**Safety Evaluation Report of Early Site Permit Application
in the Matter of Exelon Generation Company, LLC, for the
EGC Early Site Permit Site**

Supplemental Draft August 2005

U.S. Nuclear Regulatory Commission
Office of Nuclear Reactor Regulation
Washington, DC 20555-0001

Figure 2.5.2-7 Comparison of performance-based SSE spectrum for the ESP site and the mean 10⁻⁴ and 10⁻⁵ spectra

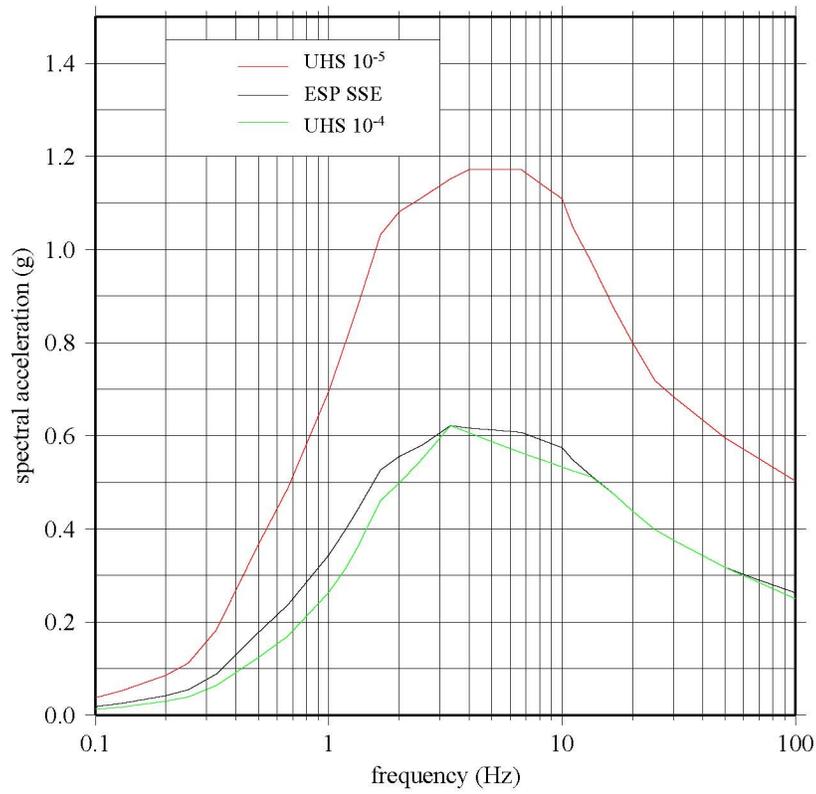
In RAI 2.5.2-7(a), the staff asked the applicant to justify the selection of the mean annual frequency of 10^{-5} as the safety performance target for the unacceptable performance of Category I SSCs as a result of seismically initiated events. In response to RAI 2.5.2-7(a), the applicant stated that the primary basis for the target 10^{-5} annual performance goal is from the results of seismic probabilistic risk assessments (PRAs) of 25 nuclear power plants (NUREG-1742, "Perspectives Gained from the IPEEE Program"), which show the median value for the mean seismic core damage frequency (CDF) to be 1.2×10^{-5} . In RAI 2.5.2-7(b), the staff asked the applicant to provide the derivation of the DF used to achieve the target performance goal of 10^{-5} . In response to RAI 2.5.2-7(b), the applicant provided the derivation and underlying assumptions used to develop the DF. SER Section 2.5.2.3.6 provides further detail on the applicant's response to RAI 2.5.2-7 as well as the staff's evaluation of the applicant's response.

In RAI 2.5.2-1(a), the staff asked the applicant justify the selection of the site-specific mean 10^{-4} UHRS as the appropriate starting point for determining the final SSE. In response to RAI 2.5.2-1(a), the applicant stated that the "design amplitude required to achieve the performance goal at each structural period can be calculated starting from the mean 10^{-4} annual probability level of the seismic hazard spectrum in the free field at the ground surface, or from the 10^{-5} annual probability level, or from any intermediate probability level." The applicant explained that it selected a 10^{-4} annual probability level as the starting point based on the precedent set in ASCE/SEI Standard 43-05. In RAI 2.5.2-1(b), the staff asked the applicant to demonstrate that the SSE envelops the site-specific response spectra from the controlling earthquakes at the reference probability level (median 10^{-5} per year) recommended by RG 1.165 or to justify why this approach was not used to determine the SSE. In response to RAI 2.5.2-1(b), the applicant stated that it did not rely on the site-specific response spectra from the controlling earthquakes at the hazard reference probability level of median 10^{-5} per year to determine the site-specific SSE. Instead, the applicant used the performance-based approach in ASCE/SEI Standard 43-05 to determine the site-specific SSE. In RAI 2.5.2-1(c), the staff asked the applicant to justify using SSC seismic fragility information, before the selection of a reactor design, to determine the site SSE. In response to RAI 2.5.2-1(c), the applicant stated that the performance-based approach "combines a conservative characterization of equipment/structure performance with ground motion hazard to establish risk-consistent SSEs, rather than only hazard-consistent ground shaking, as occurs using the hazard reference probability approach in Appendix B of RG 1.165." SER Section 2.5.2.3.6 provides further detail on the applicant's response to RAI 2.5.2-1 as well as the staff's evaluation of the applicant's response.

Figure 2.5.2-8 Comparison of performance-based SSE spectrum for the ESP site and the mean 10⁻⁴ and 10⁻⁵ spectra

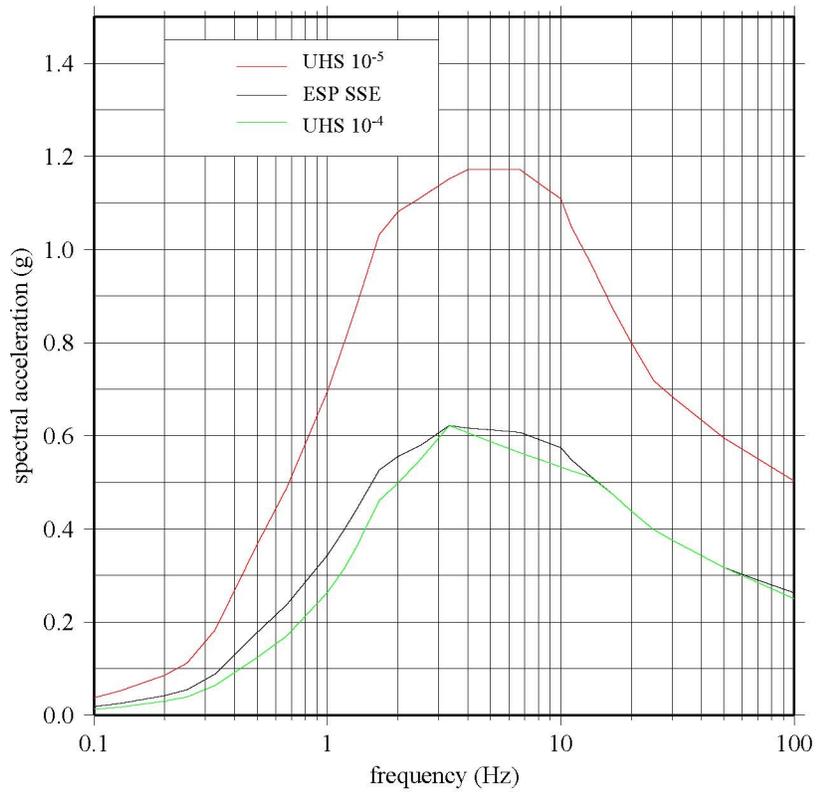
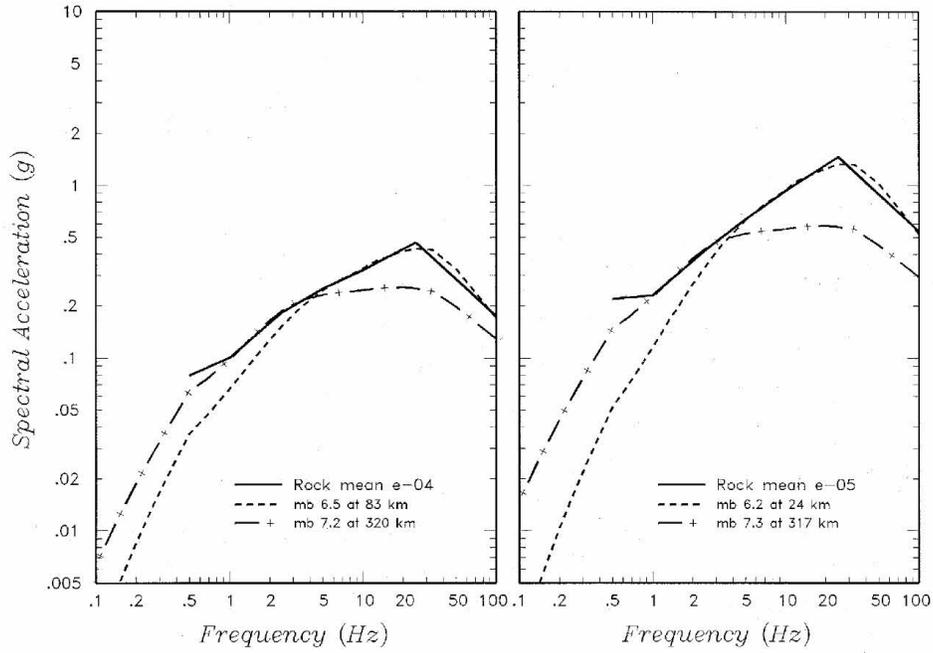
Since, as shown above in Figures 2.5.2-8 and 2.5.2-9, the high-frequency 10^{-5} controlling earthquake ground motion response spectrum from a local earthquake in the central Illinois seismic zone is significantly larger than the SSE ground motion response spectrum, the staff believes that the final performance-based SSE does not adequately represent the seismic hazard for the ESP site.

Figure 2.5.4-3 Material Damping Plot Resonant Column and Cyclic Torsion Test Results

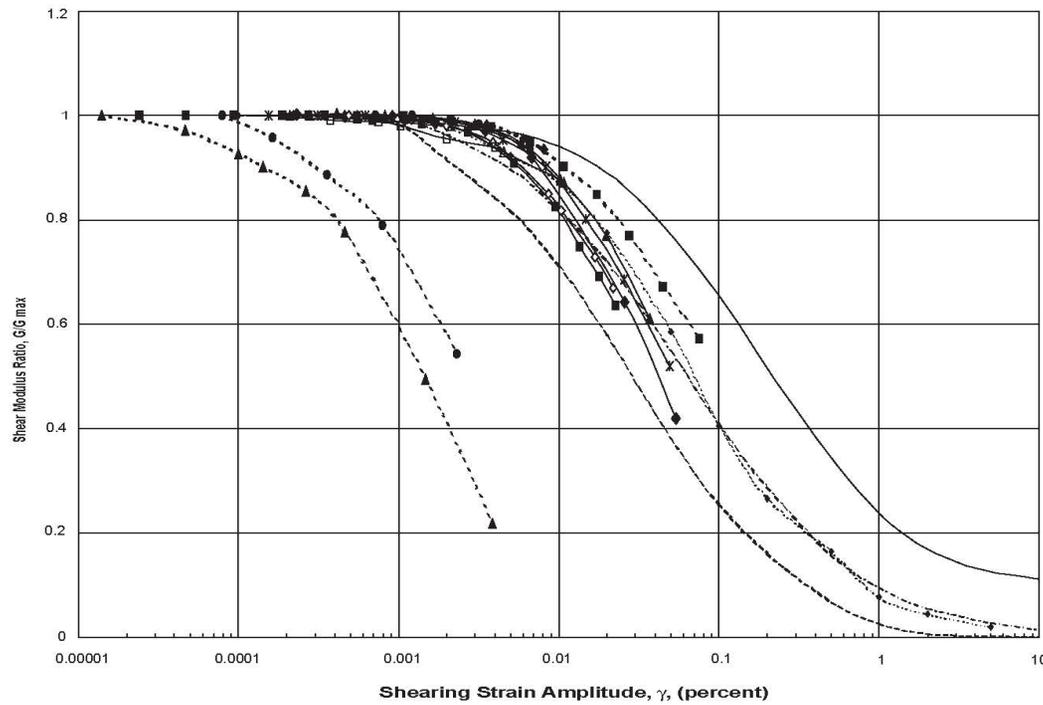
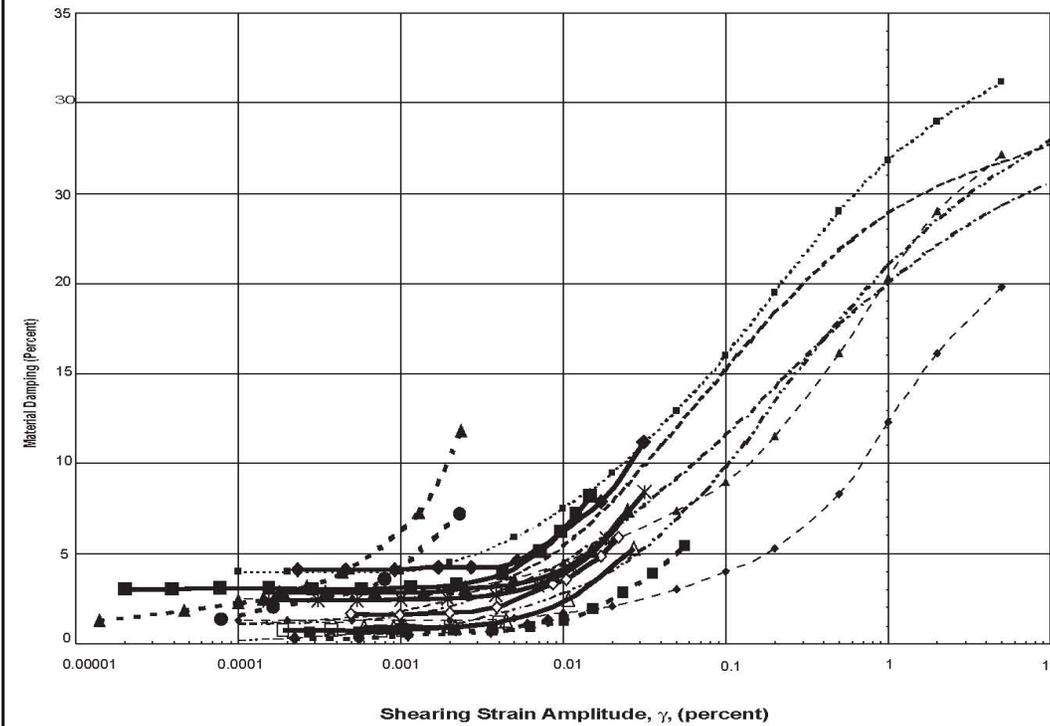
The information in Figure 5-21 (SSAR Appendix A) does indeed suggest that the hysteric damping from the laboratory tests was higher than the EPRI curves. The same conclusion can be made from the information in Figure 5-24. However, the curves that are above the EPRI damping curves are related to the resonant column tests. The fact that the resonant column data shown in Figures 5-21 and 5-24 are solid, bold lines masks the response from the torsional shear tests—suggesting that all the damping values are too high at low shearing strain amplitudes. However, material damping values from the torsional shear tests are consistent with the EPRI damping curves, as shown in Figures 4.2-2 through 4.2-6 of Appendix B to the EGC ESP SSAR.

The higher damping from the resonant column tests has been recognized for a number of years, and was noted in the EPRI (1993) set of reports. It is attributed to rate of loading effects. Typical frequencies of loading for the resonant column test range from 100 to 200 Hz for these soils. As the frequency increases from the torsional shear testing (frequencies of 0.1 to 10 Hz) to resonant column (frequencies of 100 to 200 Hz), the absolute value of damping increases by several percent. This trend is shown in Figures B.15, C.15, D.15, E.15, and G.15 of Attachment A-7 to the Appendix A report. The observed frequency effect on damping is the reason combined resonant column/torsional shear (RC/TS) tests are conducted. The frequency of loading for the torsional shear tests ranges from 0.1 to 10 Hz and therefore is much more consistent with predominant frequencies of earthquake loading.

Figure 2.5.4-6 Modulus Reduction and Damping Test Results Compared to EPRI (1993) Soil Property Curves for Test UTA-34-A

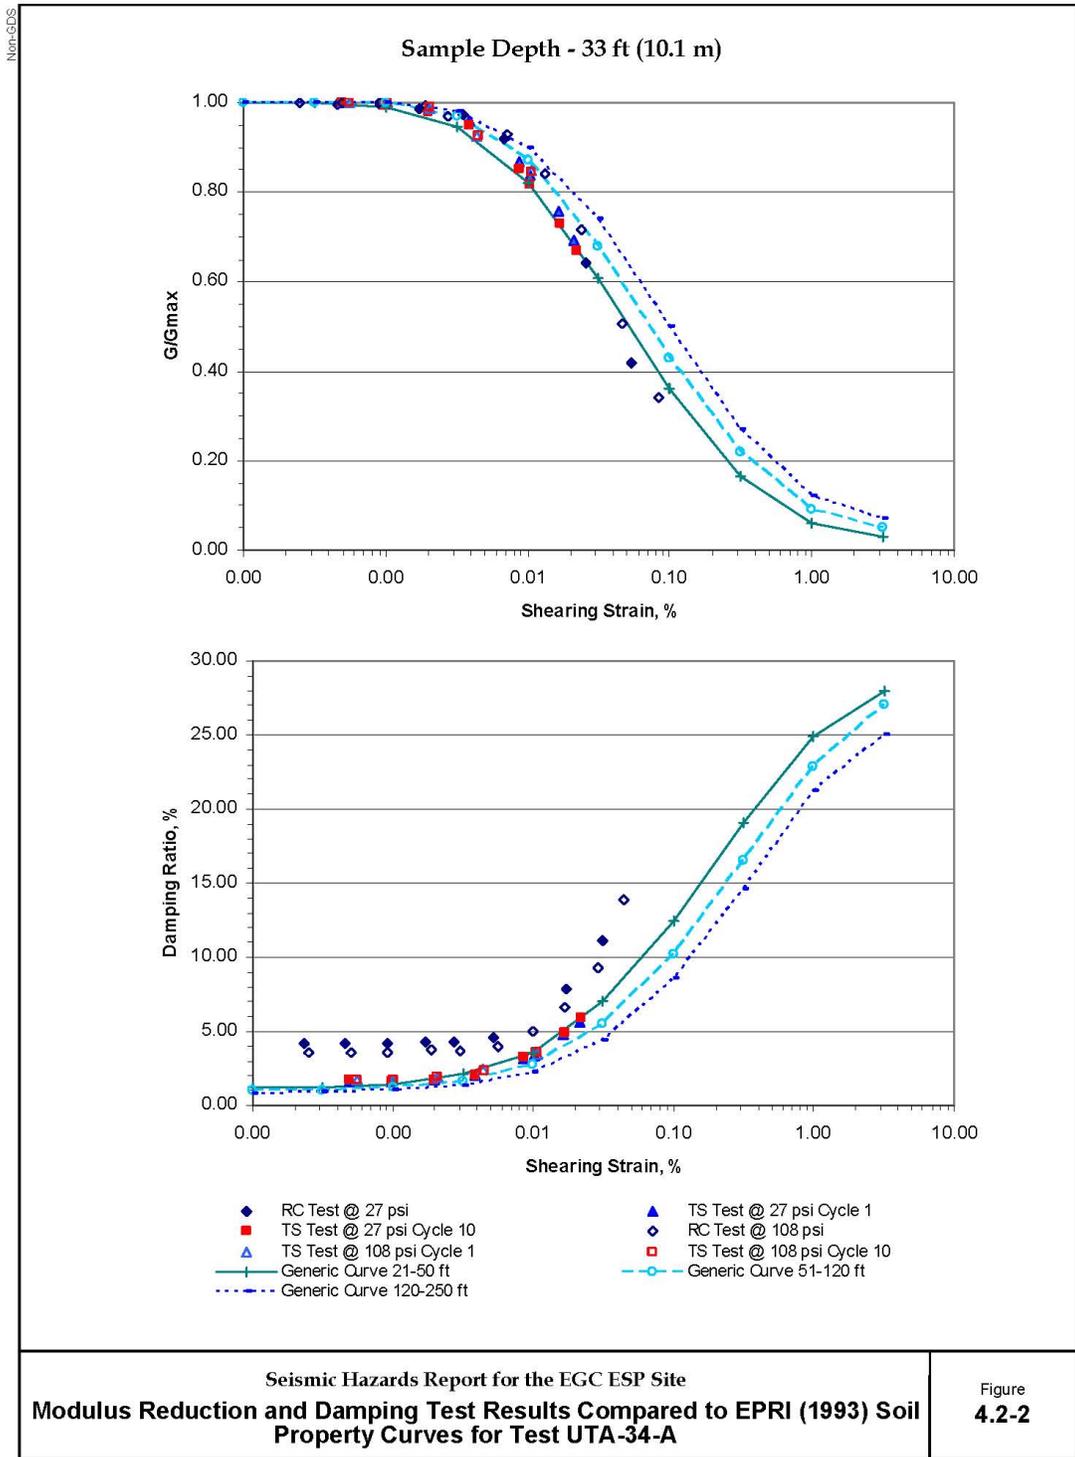
In order to verify the applicant's classification of the ESP soils as "gravelly sands to low plasticity silty or sandy clays," the staff reviewed Section 5.2.2 of SSAR Appendix A. Section 5.2.2 provides a general description of each of the soil layers underlying the ESP site and includes information on plasticity, water content, and dry density. The staff concludes from its review that the applicant's characterization of the ESP site soils is appropriate. In addition, the staff concludes that the applicant's use of the EPRI curves is justified since these curves are based on a much larger database of properties from similar soils (gravelly sands) than those obtained by the applicant for the ESP site from its four soil borings. Although the fit between the EPRI curves and the resonant column tests on the ESP site soils is weak, the staff notes that the torsional shear test data do fit the EPRI curves. The frequency of loading for the torsional shear tests ranges from 0.1 to 10 Hz, which is consistent with the predominant frequencies of earthquake ground motion. Figure 2.5.4-6, which reproduces Figure 4.2-2 from SSAR Appendix B, shows the fit between the ESP site data from the resonant column and torsional shear tests compared to the EPRI (1993) generic curves for gravelly sands to low-plasticity silty or sand clays.

Based on its review of the applicant's soil classifications and the fit between the ESP site soil torsional shear test data and the EPRI (1993) generic curves, described above, the staff concludes that the applicant's use of the EPRI shear modulus and damping curves is appropriate.
